APPLICATION FOR PERMIT TO DRILL				5. MINERAL LEASE NO: UTU-02278	6. SURFACE: State
1A. TYPE OF WORK: DRILL <input checked="" type="checkbox"/> REENTER <input type="checkbox"/> DEEPEN <input type="checkbox"/>				7. IF INDIAN, ALLOTTEE OR TRIBE NAME:

2. NAME OF OPERATOR: KERR MCGEE OIL & GAS ONSHORE L.P.				9. WELL NAME and NUMBER: NBU 1021-20E	
3. ADDRESS OF OPERATOR: 1368 S 1200 E CITY VERNAL STATE UT ZIP 84078			PHONE NUMBER: (435) 781-7024

**NBU 1021-20E
SW/NW SEC. 20, T10S, R21E
UINTAH COUNTY, UTAH
UTU-02278**

AN ON-SITE INSPECTION HAS BEEN PERFORMED ON 09/19/2007, WITH THE DIVISION OF OIL, GAS AND MINING AND SITLA. IT WAS DECIDED TO CHANGE THE LOCATION LAYOUT TO SHOW DRAINAGE REDUCTION AROUND PIT CORNER "C".

FIGURE #1

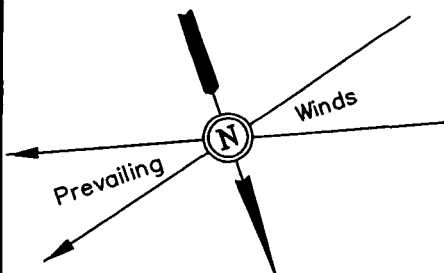
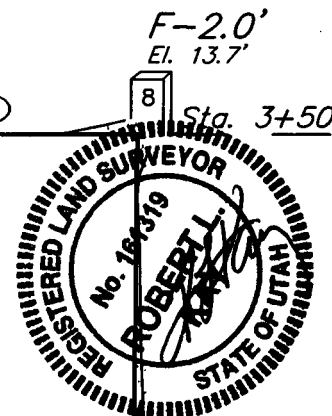
PLEASE REFER TO THE ATTACHED REVISED LOCATION LAYOUT.
